To: Kristopher Byrd, Well Construction and Compliance Section Manager
From: Joel Jeffery, Well Construction Program Coordinator
Subject: Review of Water Right Application G-18541
Date: August 20, 2018

Application # G- 18541

PUBLIC INTEREST REVIEW FOR GROUNDWATER APPLICATIONS

TO: Water Rights Section Date 8/17/2018
 FROM: Groundwater Section Joe Kemper
 Reviewer's Name
 SUBJECT: Application G- 18541 Supersedes review of NA
 Date of Review(s)

Figure 3. Well Log Summary Statistics for TRS 38S/2W-Sections 1, 2, 11 & 12

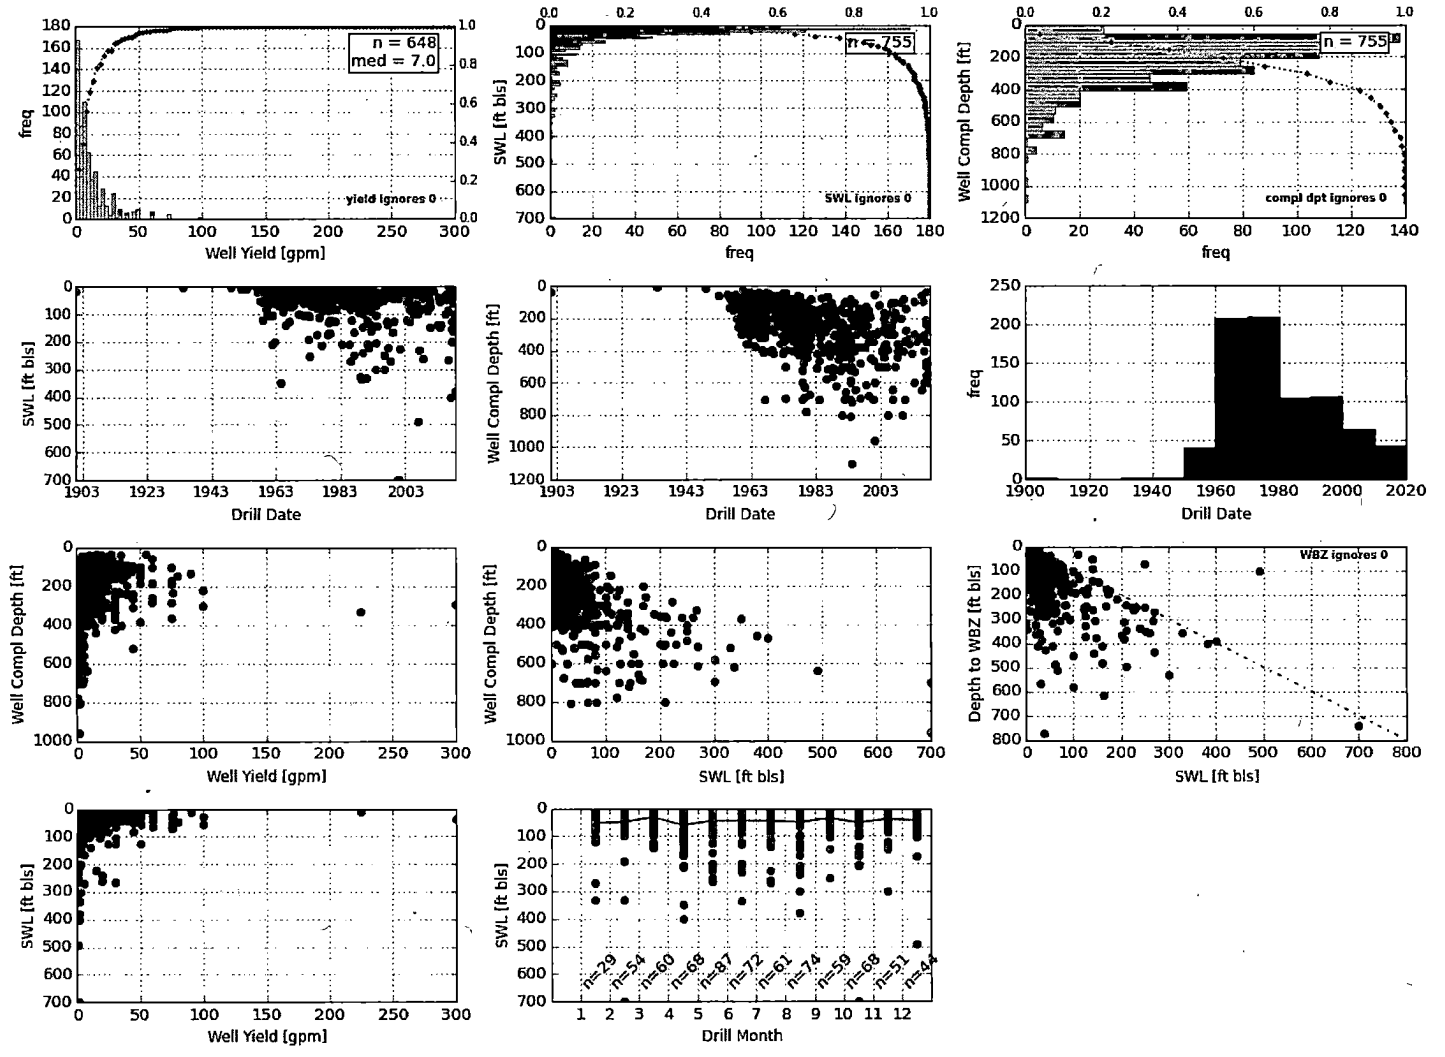
A4. **Comments:** *The applicant's wells would access a bedrock aquifer where water is typically hosted in the upper weathered and fractured zones. SWLs are usually quite shallow. Figure 3 shows summary statistics of well log reports for adjacent wells; approximately 90% of SWLs measurements are less than 100 feet BLS. Additionally, when low yield wells are tested, water levels can take several days to recover fully. If depth to water is measured soon after a well test, the measurement is often much deeper than actual aquifer conditions. Considering these lines of evidence, this review will assume that SWLs in the target aquifer will be shallower than 100 feet.

B3. **Groundwater availability remarks:** Well yields are typically low in this aquifer system; the median reported yield for wells in the adjacent 4 sections is 7 gpm (see Figure 3). There are very few SWL measurements within a mile of the proposed POA to identify long-term trends. Thus, there is not a preponderance of evidence to determine whether the resource is or is not over appropriated.

Basis for aquifer confinement evaluation: The well log for Well 1 indicates "First Water" at 338 feet BLS and a SWL of 240 feet BLS (and is assumed to be shallower). The proposed well is likely to access similar conditions. Figure 3 also shows that nearby wells encounter similar confined conditions.
